The Dow Chemical Company
Midland, Michigan 48667

Subject: Dow Chemical Company- Response to the Request for Additional Information for the renewed license of the TRIGA research reactor. License No. R-108; Docket No. 50-264

Figure 29.2 Control system block diagram

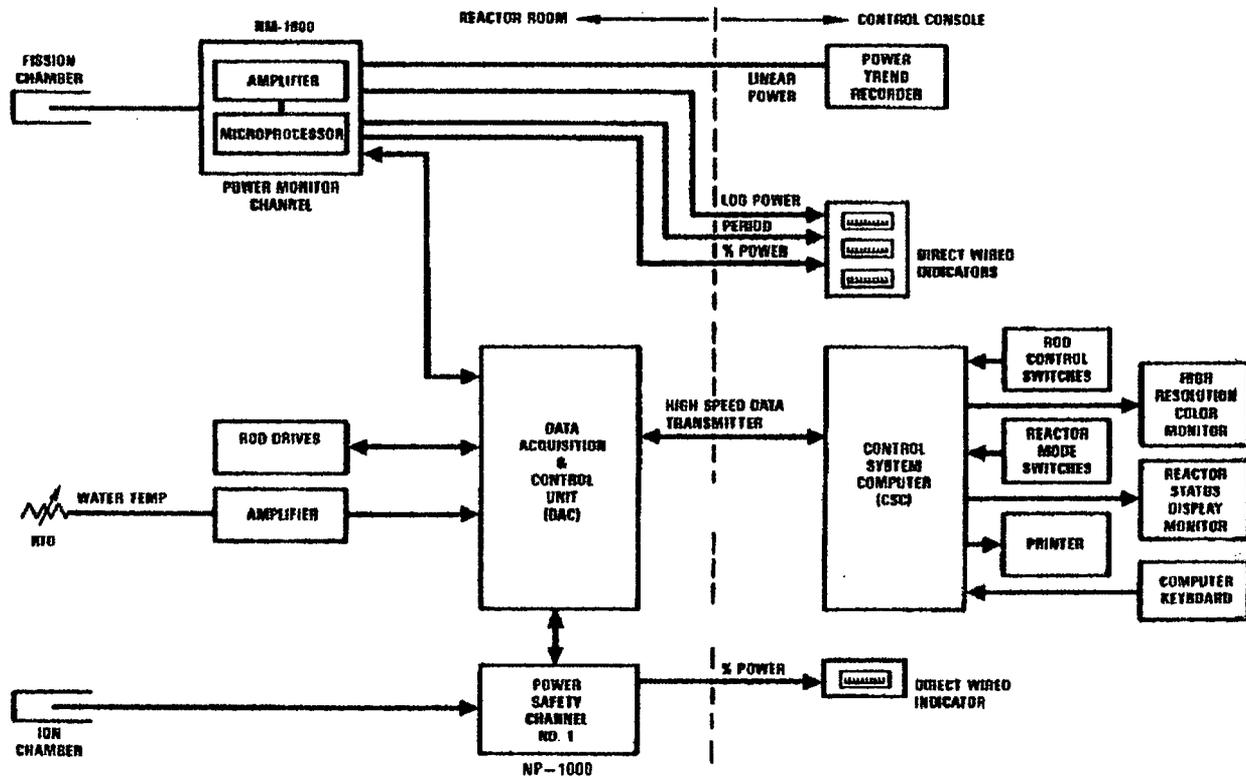
29. NUREG-1537, Part 1, Section 7.2, "Design of Instrumentation and Control Systems" requests the applicant to provide information regarding the basis for evaluating the reliability and performance of the I&C systems. DTRR SAR, Chapter G, does not provide sufficient information.
- 29.1 Please describe the design basis for the I&C system.
 - 29.2 Please provide a system description that includes block, logic, and schematic diagrams of the I&C system.
 - 29.3 Please describe the methodology and acceptance criteria used to establish and calibrate the trip and actuation setpoints or interlock functions.
 - 29.4 Please summarize how the system design is sufficient and suitable for performing the functions required for operation at the new requested power level.

29.2 The block diagram of the Instrument and control system for the DTRR is shown in Figure 29.2 below. As described in response to RAI 29.1 above, the system is based on an industry standard. Operational experience shows that it is capable and sufficient to control the DTRR for the reactor power level of 300kW. It has the following main parts: The NM1000 and the NPP1000 with their associated sensors, signal conditioning amplifiers and integrated circuits and power supplies; The Data Acquisition Computer; The Control System Computer; And the Control Console.
